Construction Division
Additions & Alteration Charges Approval Form

Company Name:	MRMLLP	Site	Gulmohar Residency
Name of the customer	Navene Reddy D-605.		
Villa/ Flat No.

GULMOHAR RESIDENCY

Details of Additions & Alterations

Description	Owners & Developers :	Date :	Promoted by
	Modi Reality Mallapur LLP	25.09.2020	Modi Properties Pvt Ltd
	Project Name & Phase :	Prepared By :	
	Gulmohar Residency	Approved By :	Soham Modi
		Scale :	N T S
Direction	N		Phone: +91-40-66335551
WORKING PLAN-1660 Sft-B1 TYPE

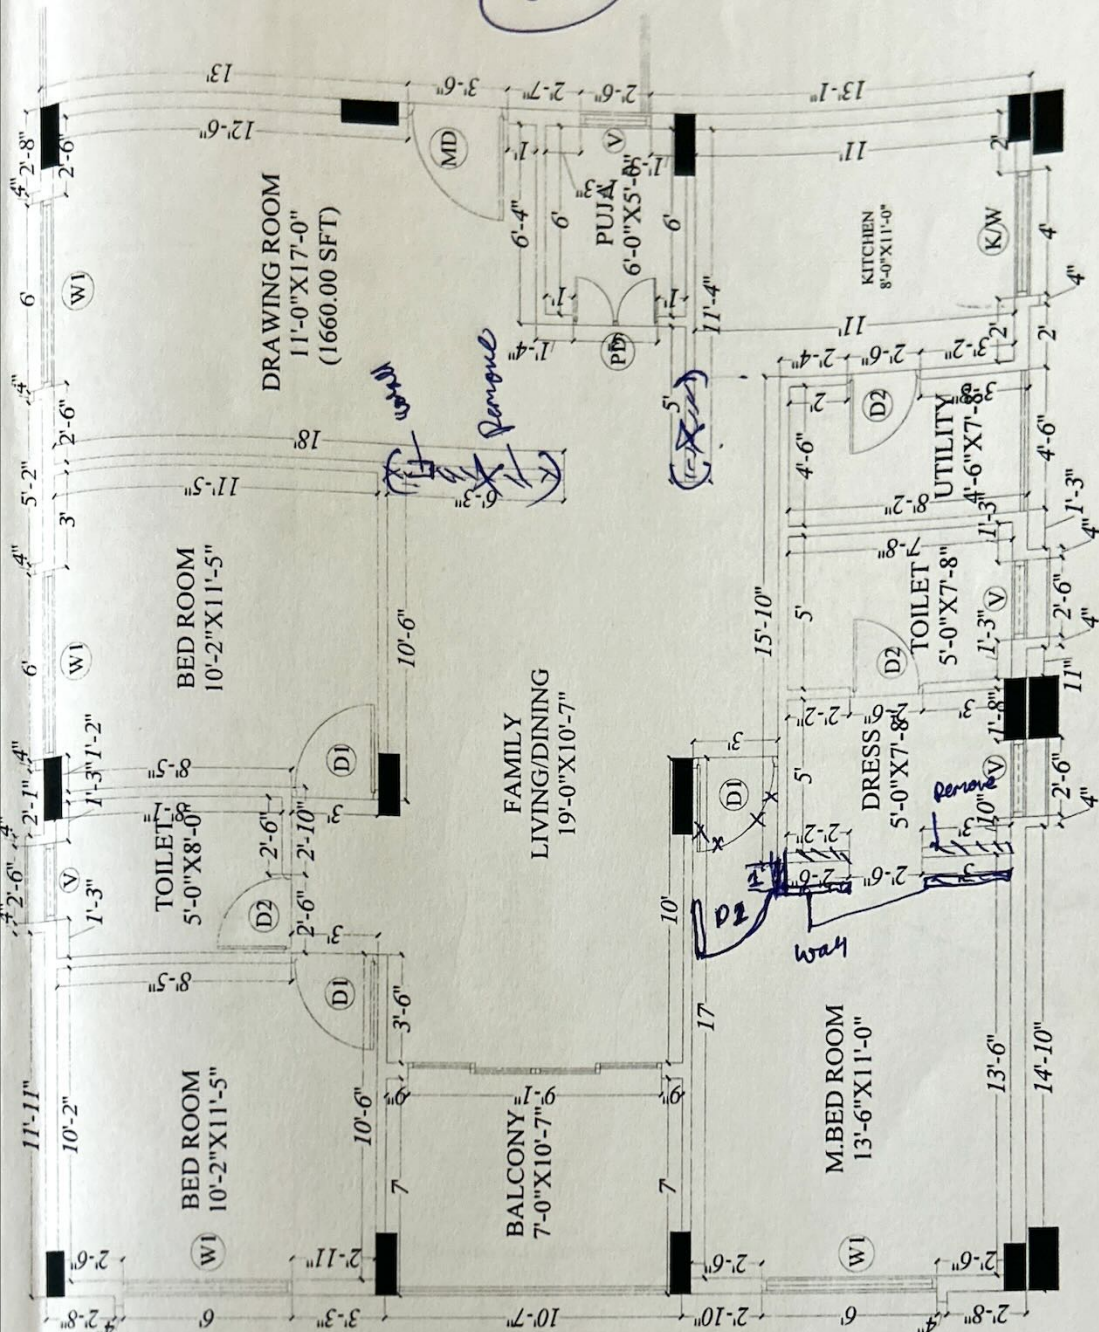
Changes in flooring:

① Regal Beige in all rooms.

kitchen, Utility & Balcony - As Default.
↓ Regal Beige in kitchen.

1) Cancite Beige - Hall, Dining,
3 Bedrooms & kitchen.

2) Balcony - Country Rosso

3) Utility - wall - country coffee

4) Utility floor - Black Berry.

Description	Owners & Developers :	Date :	Promoted by
PLUMBING PLAN-1660 Sq Ft (B1-TYPE)	Modi Reality Mallapur LLP	04.09.20	Modi Properties Pvt Ltd
	Project Name & Phase :	Prepared By :	
	Gulmohar Residency	Approved By :	
		Scale :	
		N.T.S	Phone:-+91-40-66335551

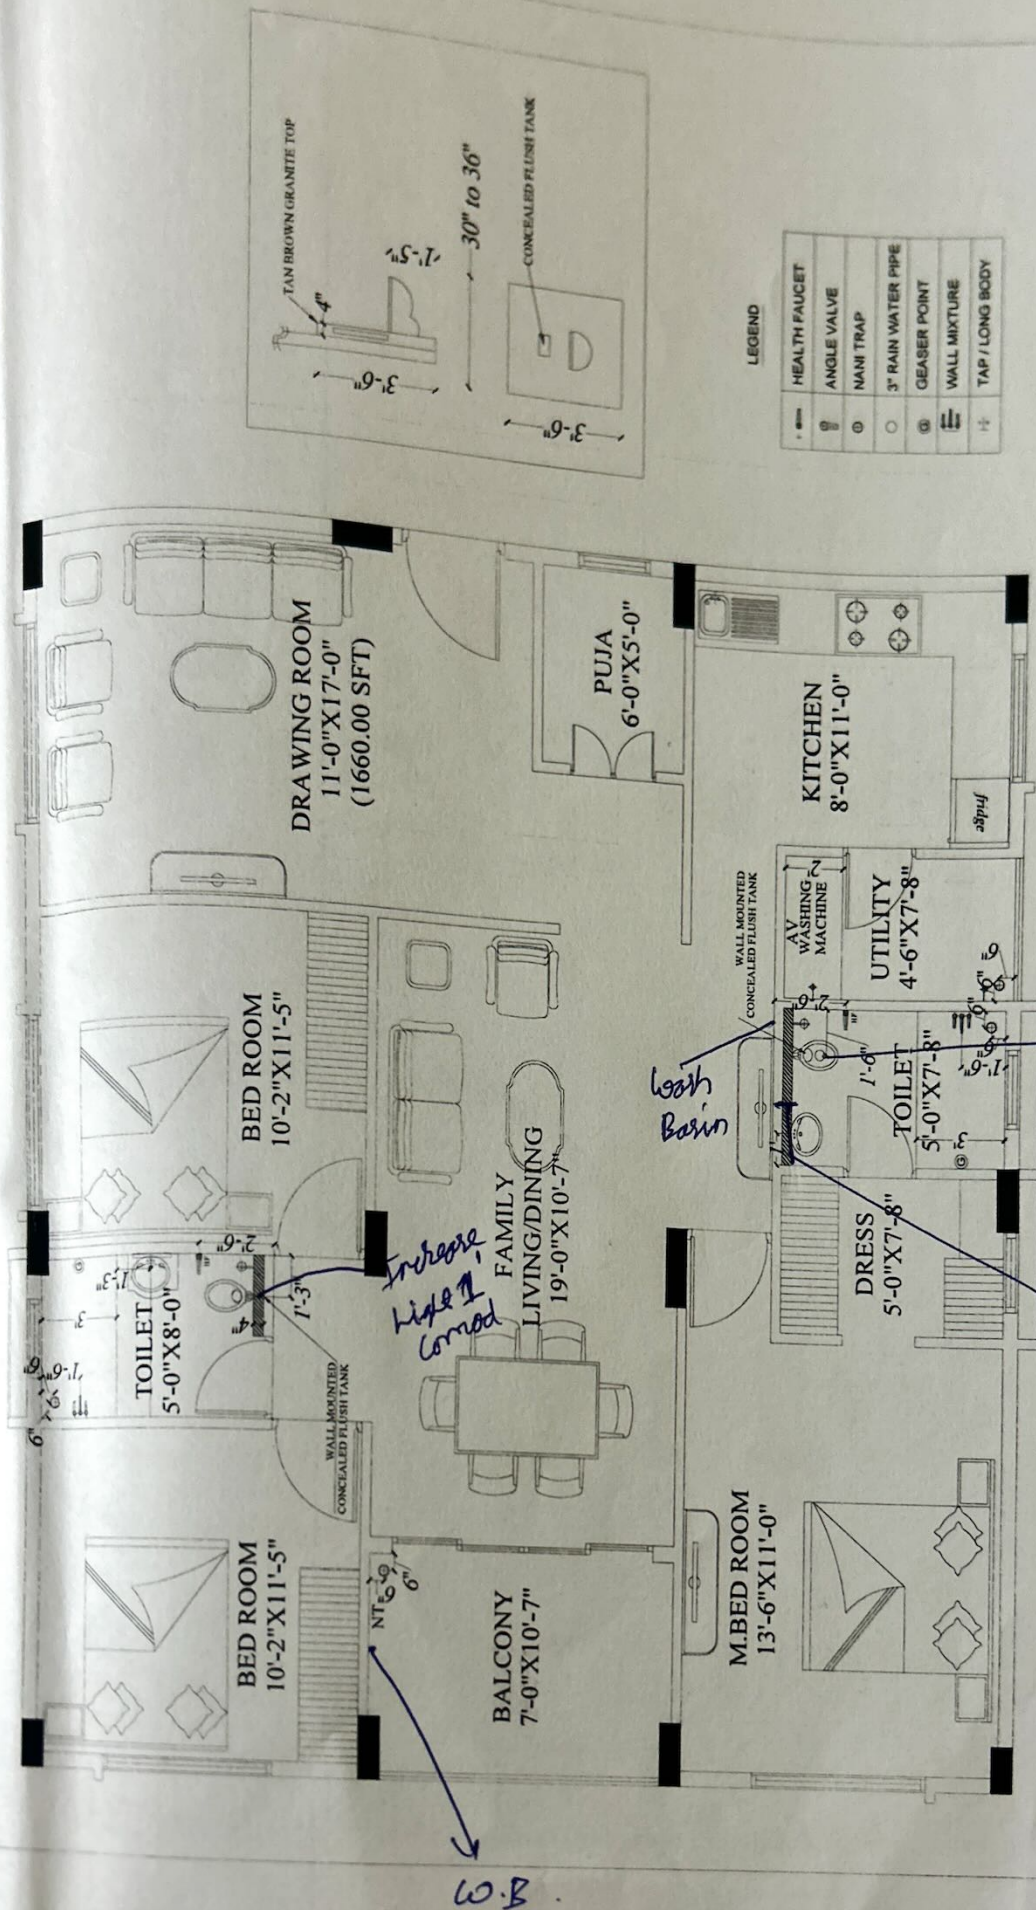
Choice of Bathroom tiles, CP fittings & Sanitary ware:

① C.T - Wna
M.T - Ultra

① Water proofing by Customer, Inform at stage

ELECTRICAL PLAN - B1 TYPE-1660 sq ft

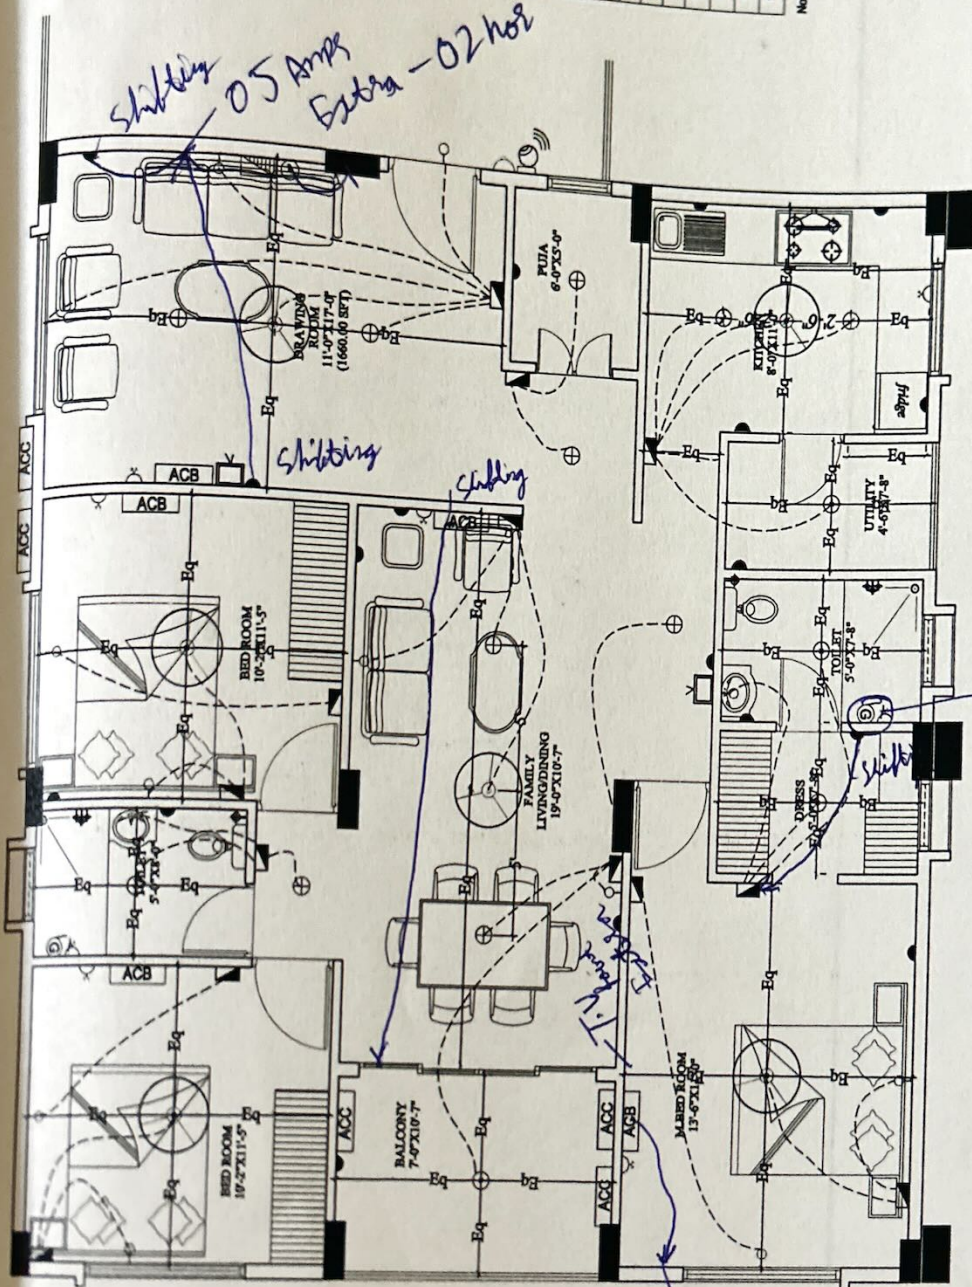
Changes in electrical points: (mark on plan)
